ADMINISTRATIVE CONTROLS

6.0 ADMINISTRATIVE CONTROLS

FIGURE 6.2.2-1a
UNIT ORGANIZATION

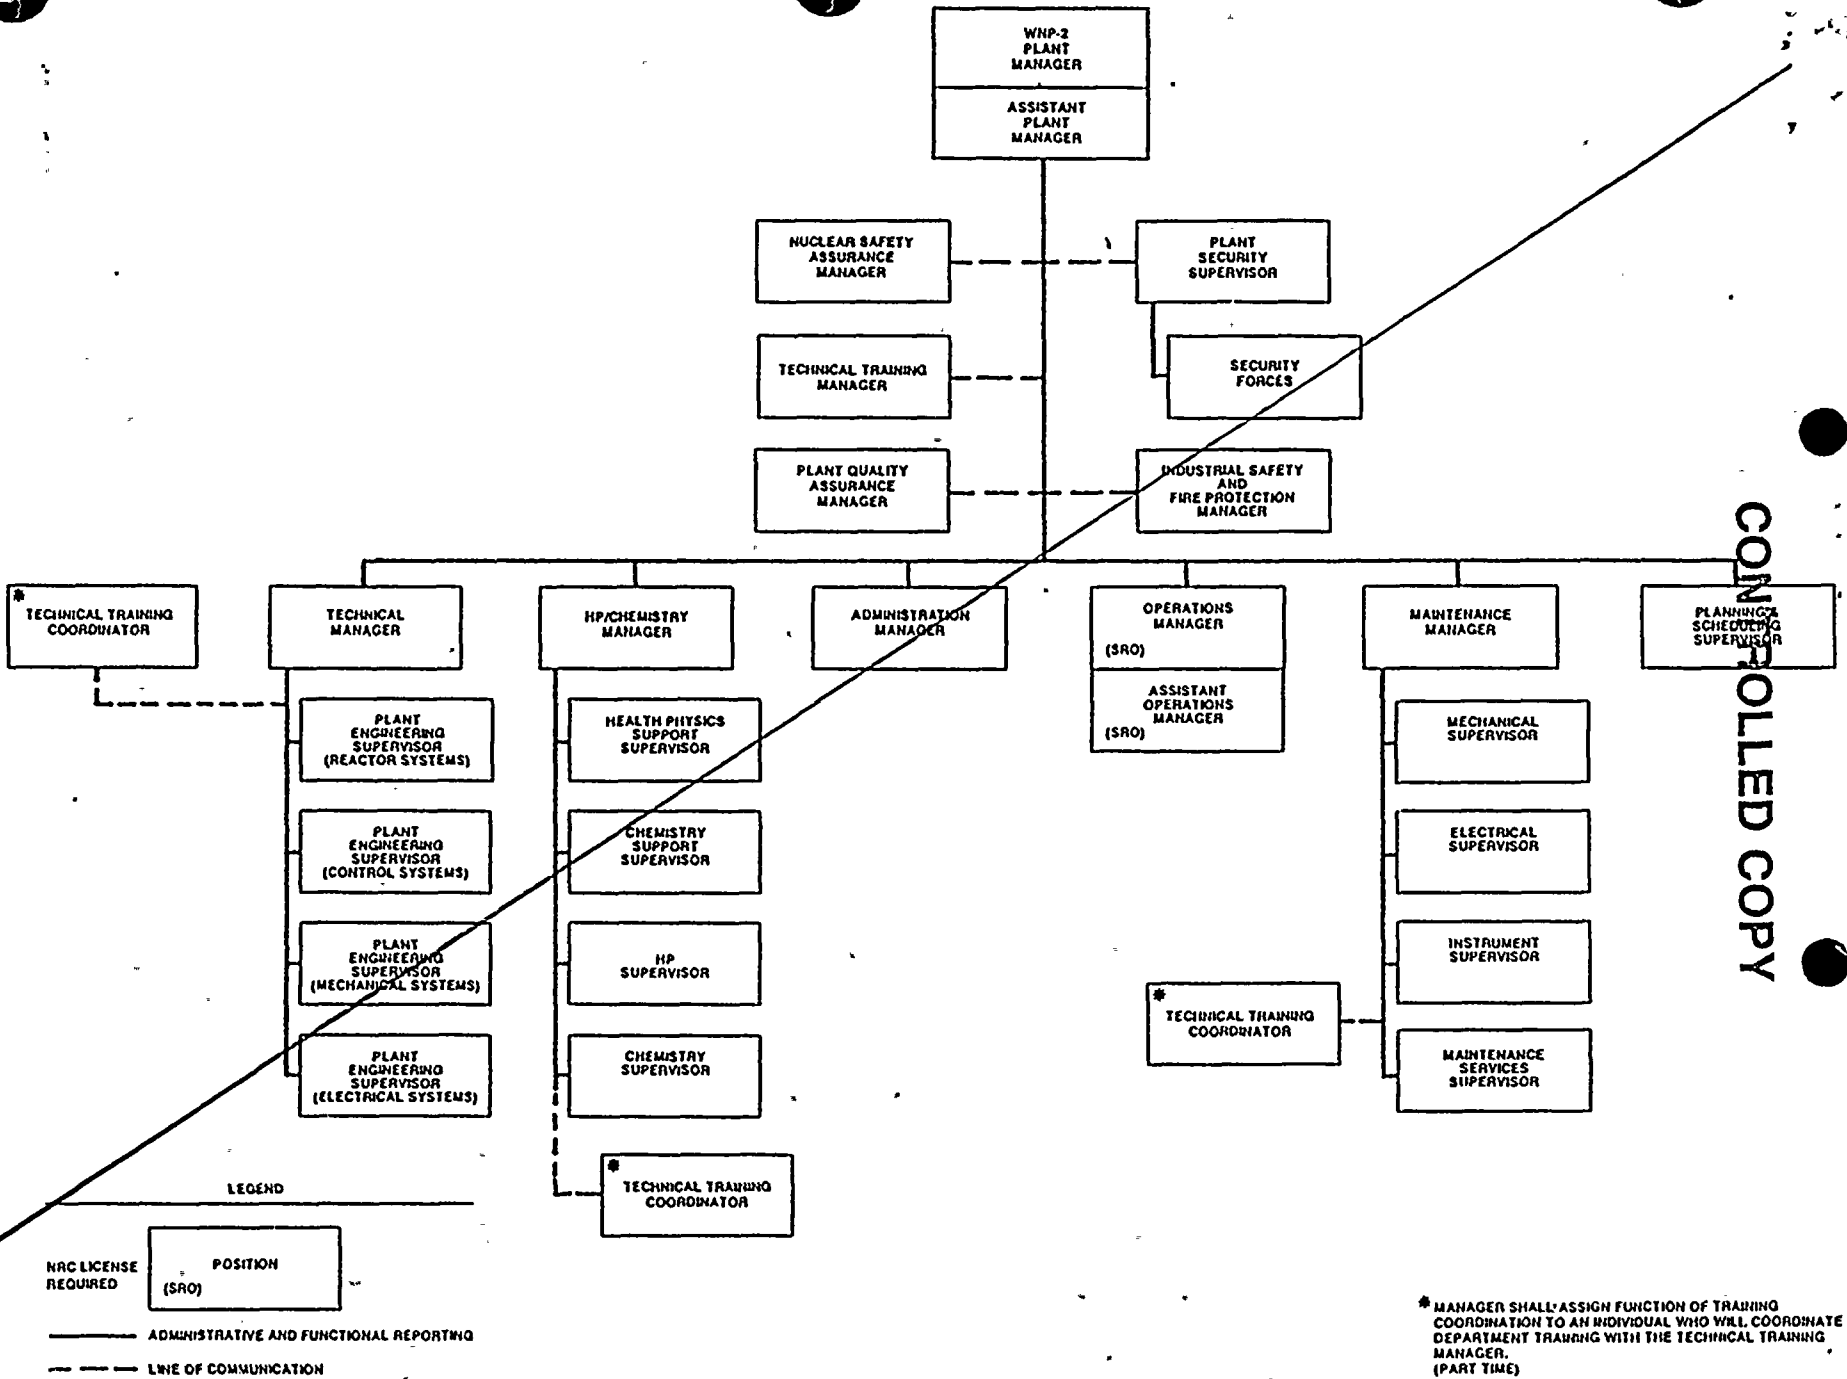
~~6.2.2 The unit organization shall be as shown on Figures 6.2.2-1a and 6.2.2-1b, and:~~
